Application for Variation of an Environmental Permit

Project Title: Central-Wanchai Bypass (CWB) Including Its Road Tunnel and Slip Roads  
工程項目名稱: 中環灣仔繞道包括其行車隧道及連接路

**Environmental Review Report for  
Alternative Arrangement for Submission of As-built Drawings for Landscape Works of CWB**

Highways Department 路政署   
 Major Works Project Management Office   
 CENTRAL - WAN CHAI BYPASS AND IEC LINK

LOCATION OF AIR SENSITIVE RECEIVER

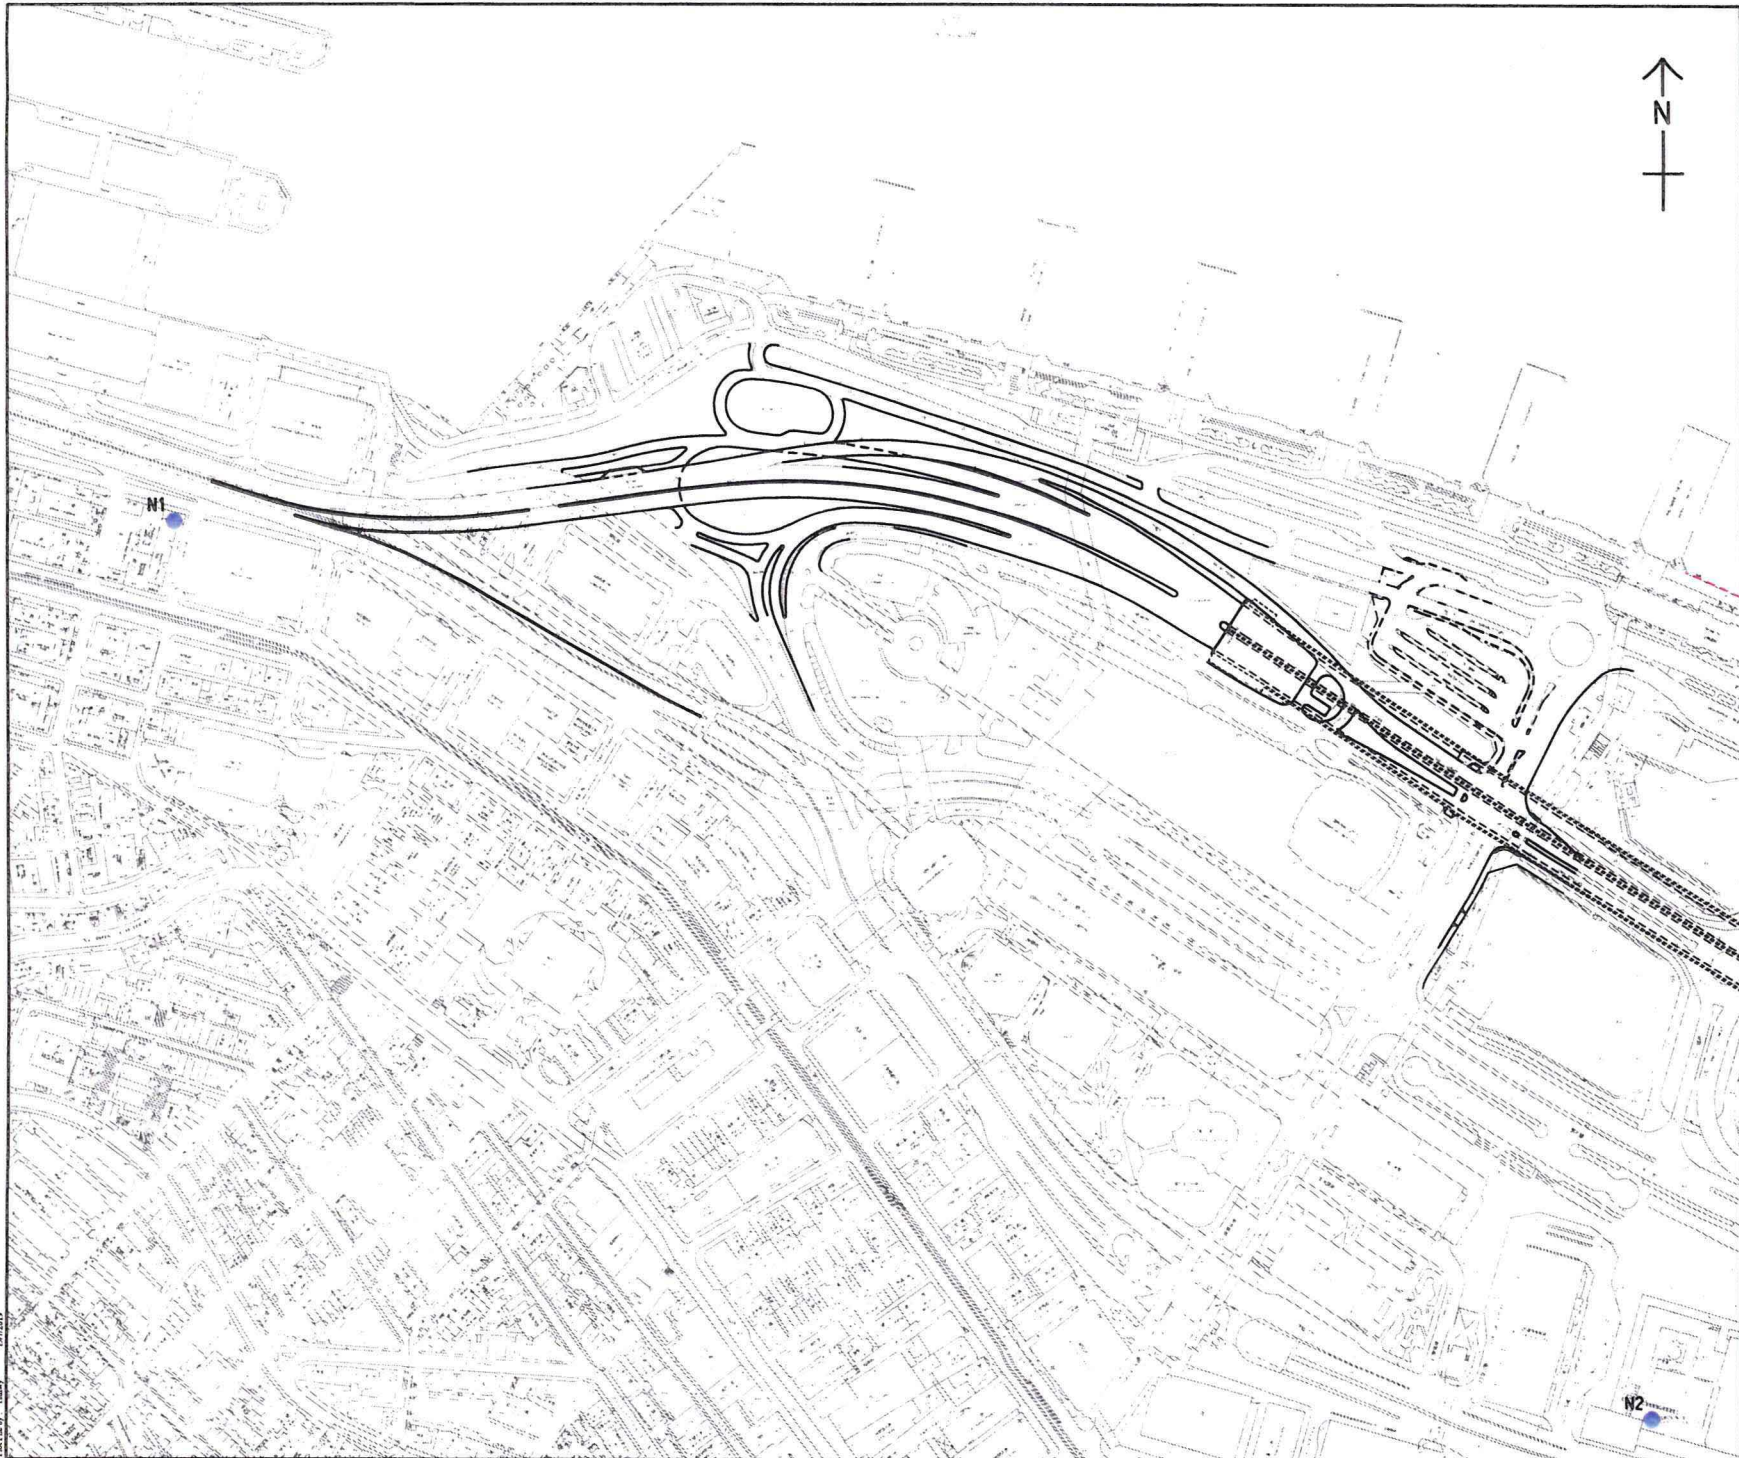
- 2.1.2 Under the revised scheme (with no change in traffic speed compared to the original scheme), a portion of westbound traffic to the RSF will utilize the retained RSF eastbound structure. Referring to Figure 3.1.1 in the approved EIA report (AEIAR-041/2001), the closest nearby Air Sensitive Receiver (ASR) is A5 (i.e. Harbour Building). The separation distance between the traffic on the modified RSF and the ASR A5 would be slightly decreased by about 5m.

- 2.1.3 The closest nearby ASR A5 is a G/IC building which adopts centralized air conditioning and has no window opening for ventilation. The fresh air inlet is located at the roof of the building (approx. 96m), which is far above the RSF level, and the building is at about 22m distance away from the RSF down ramp horizontally. Hence, there will be no likelihood of exceedance of AQO and adverse air quality impact on ASR A5 arising from the revised scheme. The location of ASR A5 is shown in **Figure 2.1**.

LOCATION OF NOISE SENSITIVE RECEIVER

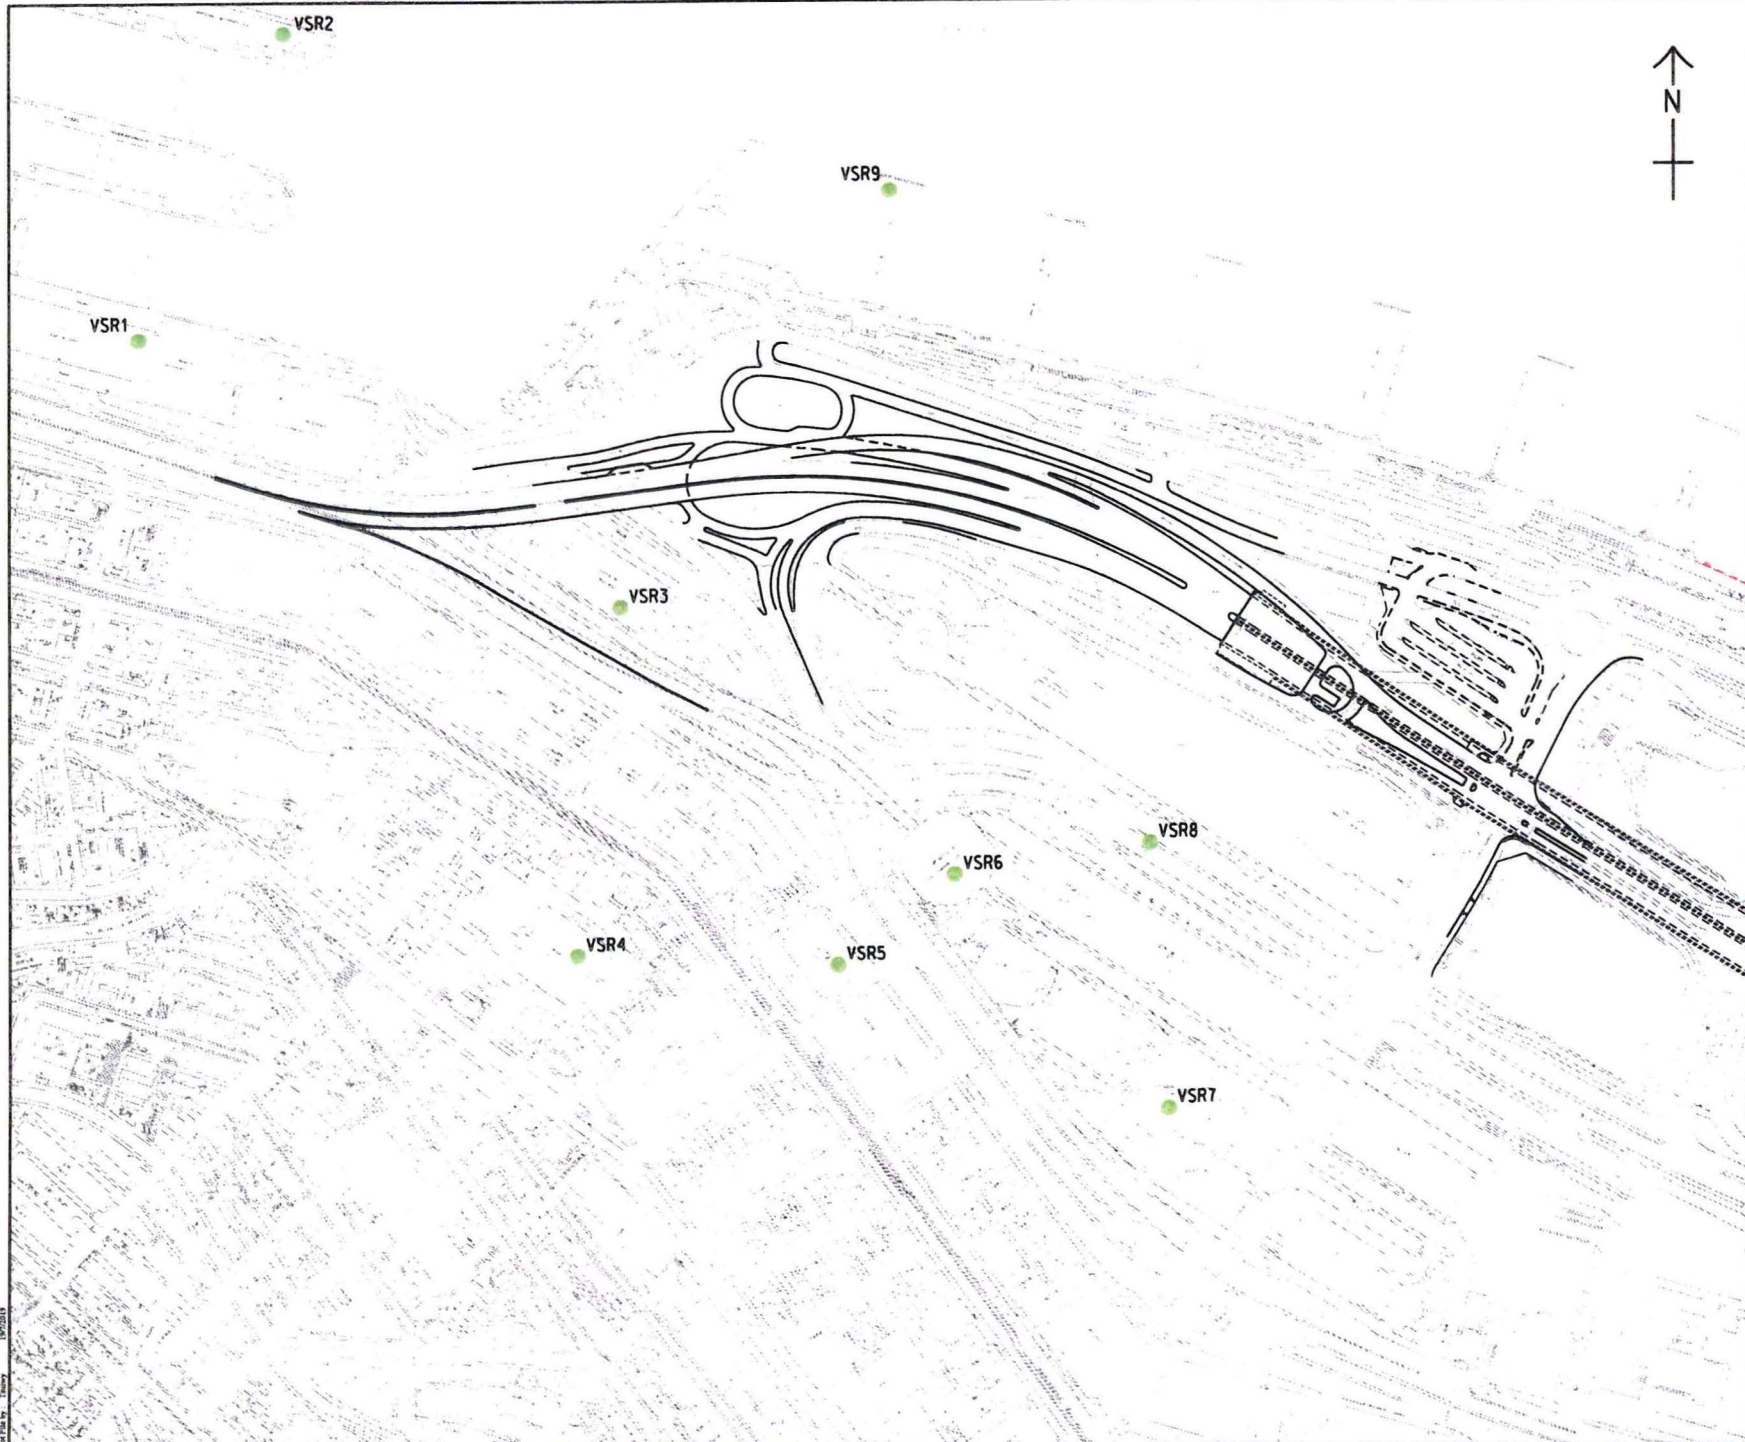
- 2.2.4 The nearby Noise Sensitive Receivers (NSRs) (i.e. N1, The Bauhinia Hotel - Central (previously called Korea Centre in the EIA Report) and N2, City Hall) as identified in the approved EIA report should not rely on openable windows for ventilation. Also, the buildings in the close proximity to and facing the concerned down ramp are commercial use, except that the Harbour Building is a G/IC building. They have centralized air conditioning and also do not rely on openable windows for ventilation. The locations of NSR N1 and N2 are shown in **Figure 2.2**.

- 2.2.5 The closest nearby NSR identified in approved EIA report is N1, which is located over 100m away from the west side of the concerned RSF eastbound down ramp. It should be more sensitive to the nearby carriageway at its front instead of the concerned RSF down ramp. Under the revised scheme, the westbound traffic will be shifted slightly to the north, i.e. further away from N1. It is anticipated that there will be no significant change to traffic noise impact on the closest nearby NSR, N1, due to the revised scheme.

LOCATION OF  
 VISUAL SENSITIVE  
 RECEIVER

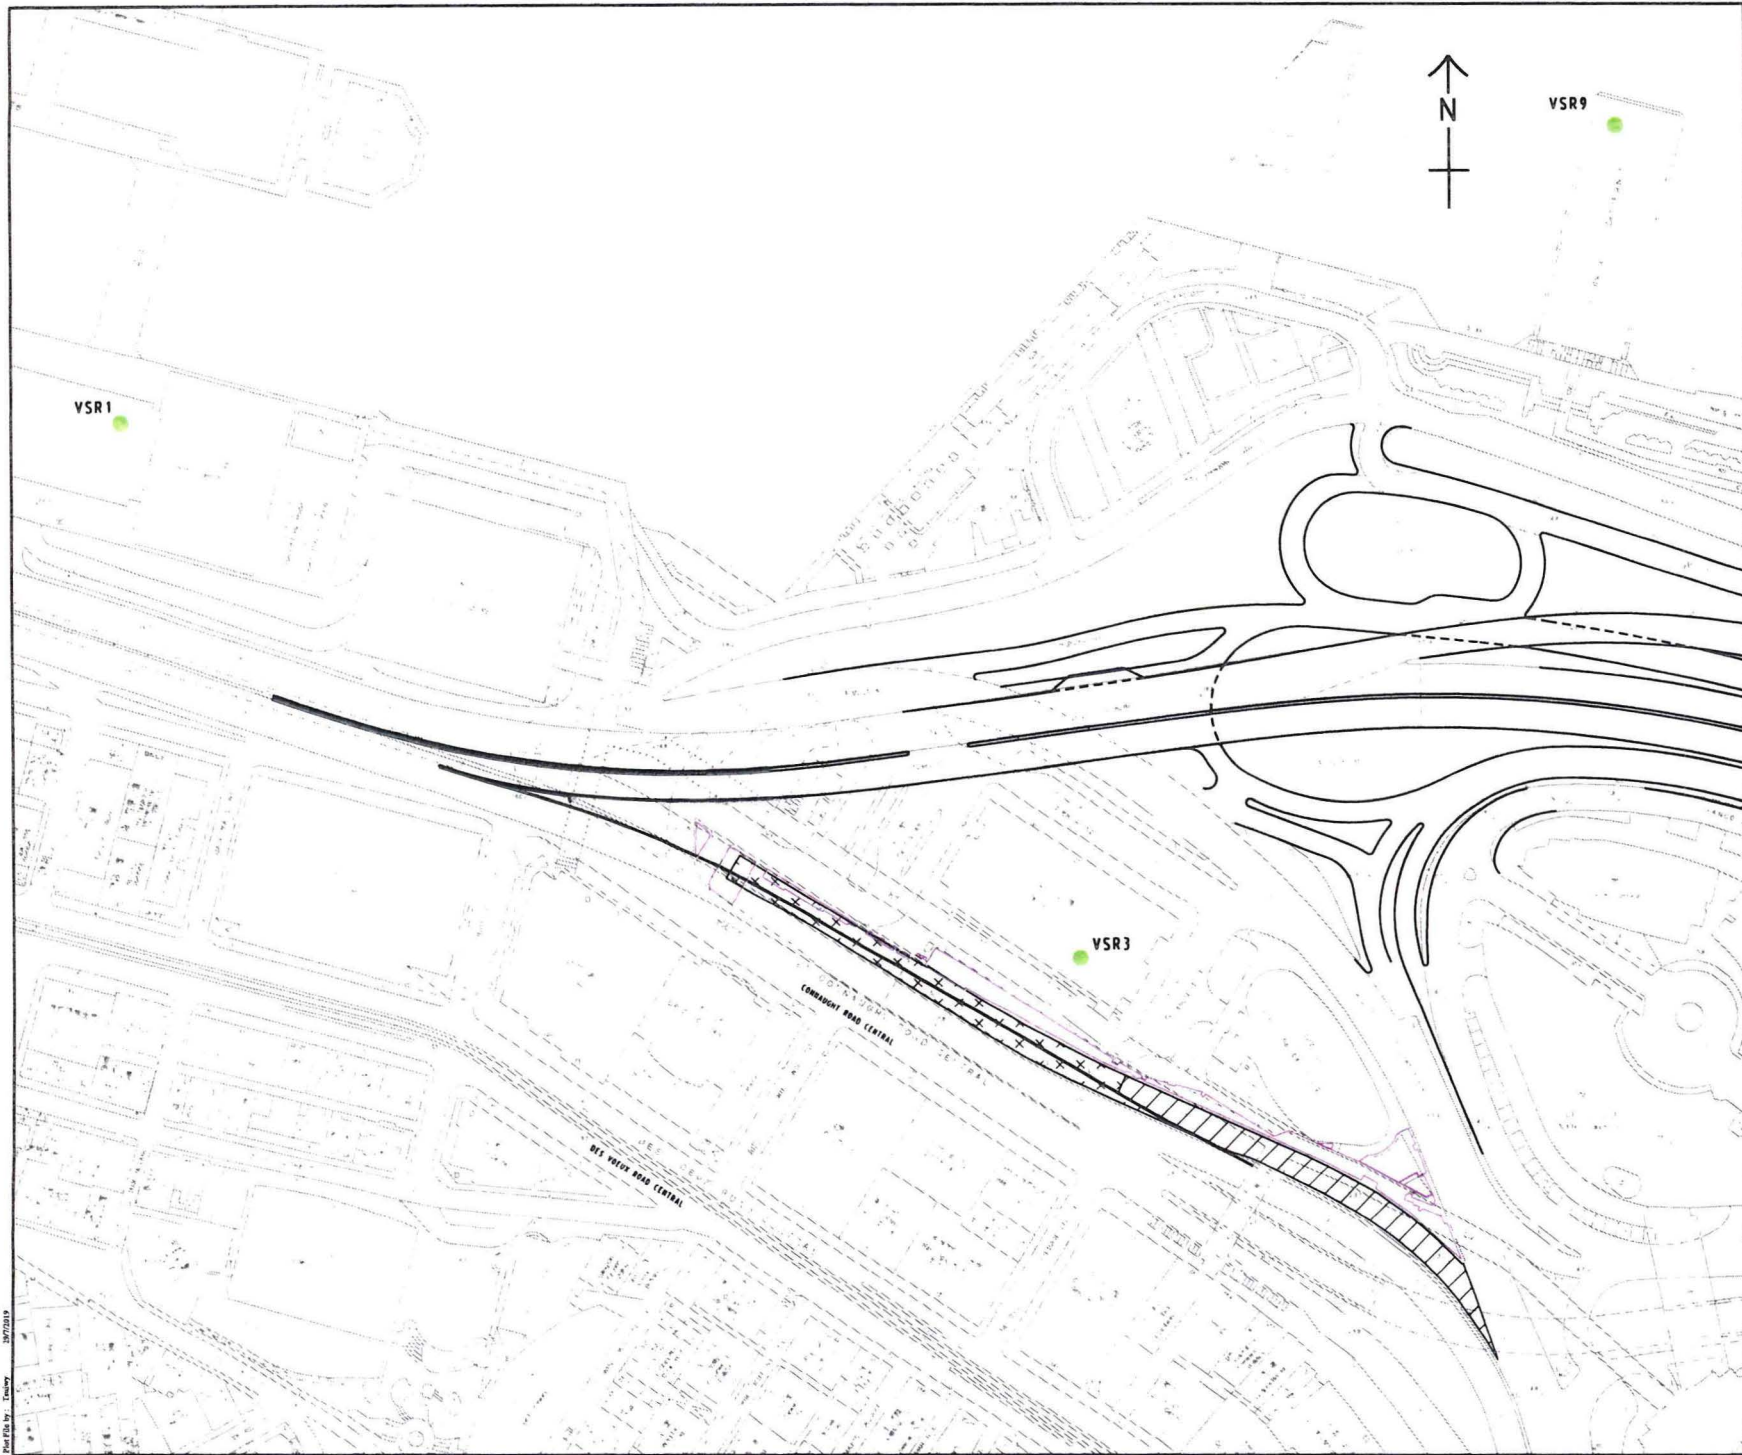
- 2.3.5 Regarding the VSRs in the vicinity of RSF, VSR1 to VSR9 are the nearby VSRs. However, these VSRs should be referred to have potential visual impacts from the works such as "*construction activities, at grade slip roads, Rumsey Street Flyover Extension, West Ventilation Building & tunnel portal*", but no specific mentions of the concerned demolition of existing RSF eastbound structure. The locations of VSRs are shown in **Figure 2.3**.
